MEMORANDUM TO: Louis M. Shotkin, Chief
Reactor and Plant Systems Branch
Division of Systems Research

SUBJECT: SUMMARY OF MEETING WITH ORNL ON CANDU 3 SYSTEMS
RESEARCH (FIN #2015)

A public meeting was held in the Nicholson Lane Building/South, Rockville, with Oak Ridge National Laboratory (ORNL), the NRC staff, AECL-CANDU, and AECL Technologies on February 10, 1993. The purpose of the meeting was to: 1) have ORNL present a summary of the CANDU systems research findings and insights that were developed as a result of the ORNL study, 2) solicit comments, and 3) obtain additional information from AECL and AECL Technologies in a number of different areas of the plant design. A List of attendees is attached. Copies of the view graphs are available on request. Highlights of the meeting are summarized below.

FIGURE 2.3.12-5 SHUTDOWN SYSTEM NO. 2 - BLOCK DIAGRAM

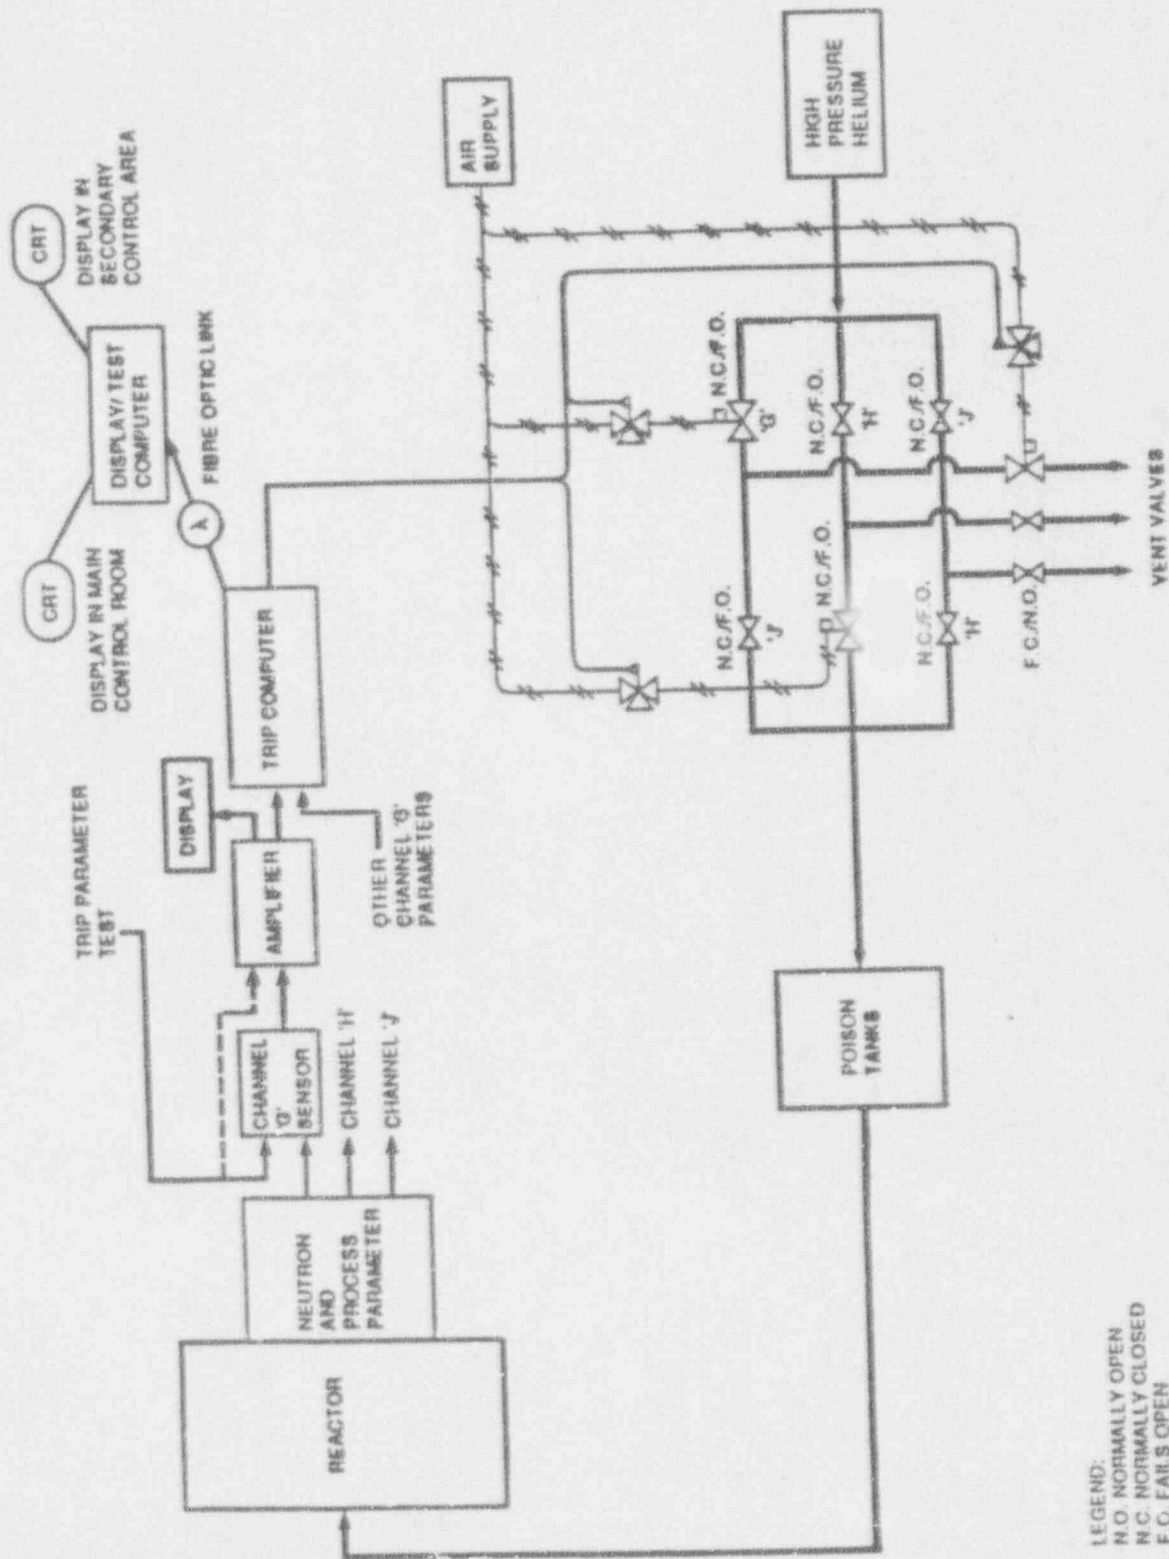
6. AECL-Technologies stated that during a Loss of Feedwater event (i.e., break in the Reactor Building) the shutdown control system would not be available because it is not currently qualified for accident environment conditions. AECL is currently re-evaluating this design. The auxiliary feedwater system will be available for this type of event. AECL-Technologies indicated that on a loss of feedwater, if SDS1 or SDS2 is not available, timely operator action is very important. AECL stated that the SDS2 system is a faster shutdown system than SDS1. L.Rib (AECL-Technologies) agreed to provide the design schematic showing the SDS2 helium line vent valves.
